Appendix 1

Observations on Hydrology and Hydrogeology: Environmental Statement Chapter 7 and Appendix 7

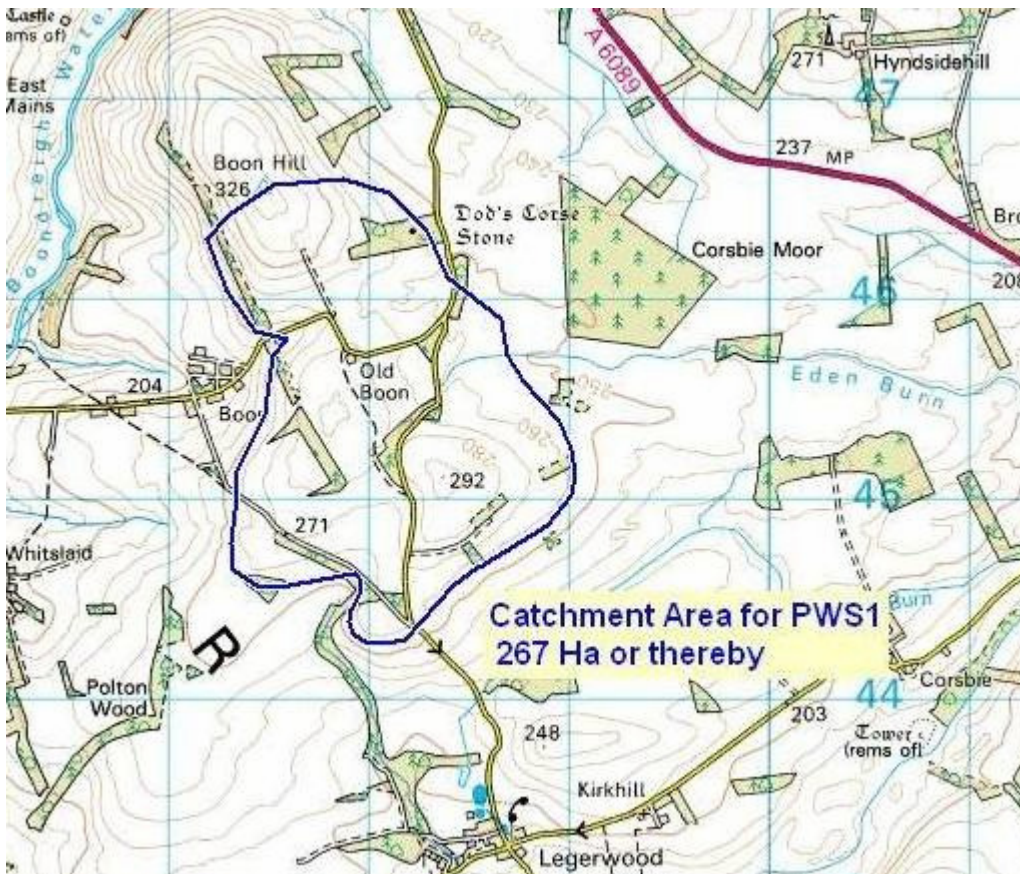
The catchment area for PWS 1 shown on drawing Fig 3.1 is underestimated by a factor of at least 24. We estimate the catchment area to be 267Ha or thereby, see below. Groundwater sources 1,2,3,4 & 5 (Applicant's Figure 3.1) are potentially in danger from construction work to the north of them.

PWS 1 has a catchment area of approximately 0.11km² ie 11ha. **This is underestimated by a factor of at least 24.** We estimate the catchment area for PWS 1 to be 267ha or thereby. (see map)
